Jordan Cove comments,
Oregon Department of State Lands,
775 Summer St. N.E., Ste 100,
Salem, OR 97301-1279

This cover letter and the narrative contained in this transmittal are submitted in response to a solicitation for comments on the Jordan Cove Energy Project LP Department of State Lands removal and fill permit APP0060697.

Comments of Janet Hodder in response to a solicitation for comments on the Jordan Cove Energy Project LP Department of State Lands removal and fill permit APP0060697.

a. LNG terminals should not be sited in areas close to population centers (SIGTTO 1997).

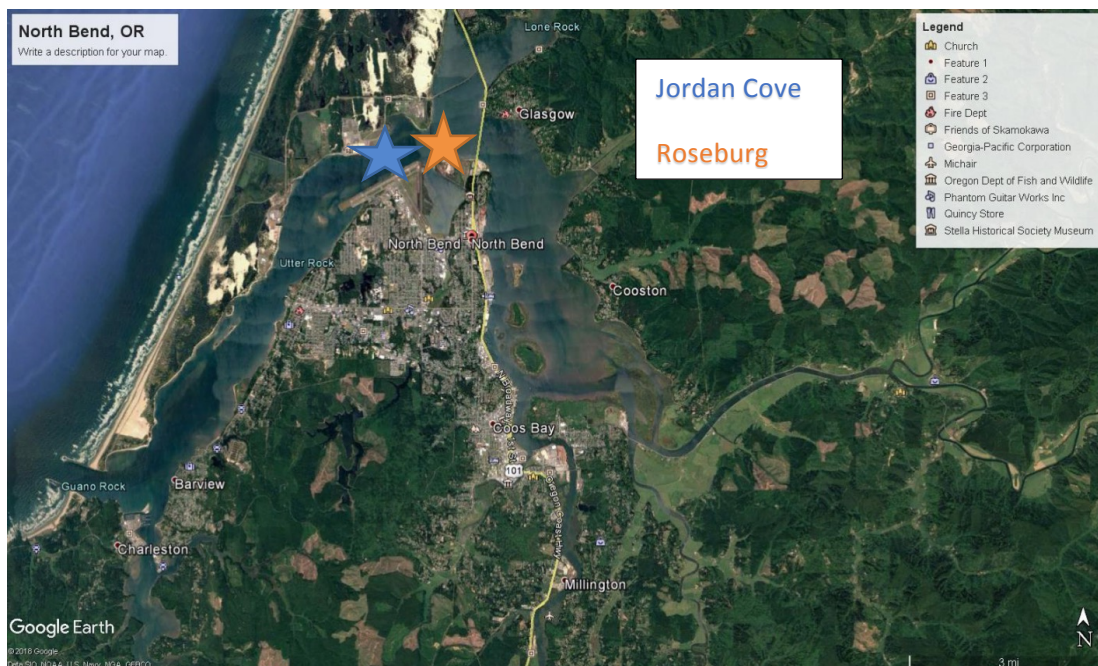
The LNG plant, access slip and channel are the sites of the largest amount of fill and removal activity in this permit. Should the reader of this permit not be familiar with the proximity of the proposed site to population centers, the location of the Jordan Cove plant is noted by the blue star on the map below. Note the proximity to the towns of North Bend and Coos Bay, the largest municipal areas on the Oregon coast, with a combined population of over 25,000 people.
